### **Remarks**

The Office Action dated February 21, 2006, indicated that the drawings are objected to; the claims are objected to; claims 1-10 stand rejected under 35 U.S.C. §112(2) for alleged nonconformance to current U.S. practice; claims 1, 3, 5 and 9 stand rejected under 35 U.S.C. §103(a) over Pan *et al.* (U.S. Pat. 5,834,358) in view of Ajuria *et al.* (U.S. Pat. 5,837,612); claims 2, 6 and 8 stand rejected under 35 U.S.C. §103(a) over Pan in view of Ajuria and further in view of Peterson *et al.* (U.S. Pat. 6,545,299); claims 4 and 10 stand rejected under 35 U.S.C. §103(a) over Pan in view of Ajuria and further in view of Lam (U.S. Pat. 6,413,828); and claim 7 stands rejected under 35 U.S.C. §103(a) over Pan in view of Ajuria and Peterson, and further in view of Lam.

FIG. 3

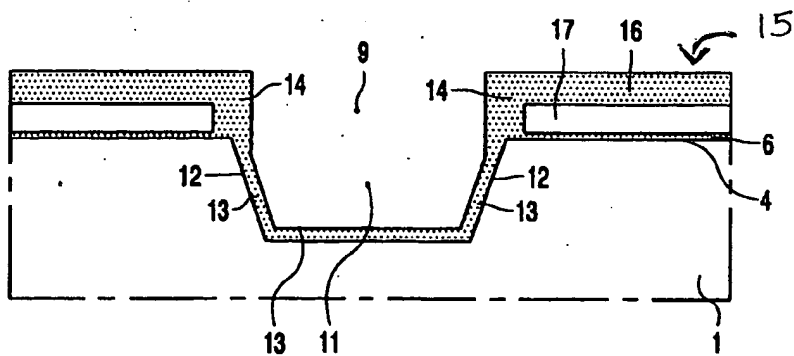
With respect to the objection to the drawings, Applicant has amended FIG. 3 to reflect an upper side 15 in a manner commensurate with the Examiner's request and the discussion in the Specification. Applicant requests that the objection to the drawings be removed.

FIG. 3:       Reference no. '15' added as identified at page 4, line 33  
                  of the specification.

Attached please find one replacement sheet of Drawings, in which FIG. 3 has been amended. Also attached is one annotated sheet, showing Applicant's amendments (shown in red ink) within the replacement sheet. The minor amendments are supported by the specification. No structural changes have been made to the drawings, and no new matter has been added. The changes in the drawings are as follows:
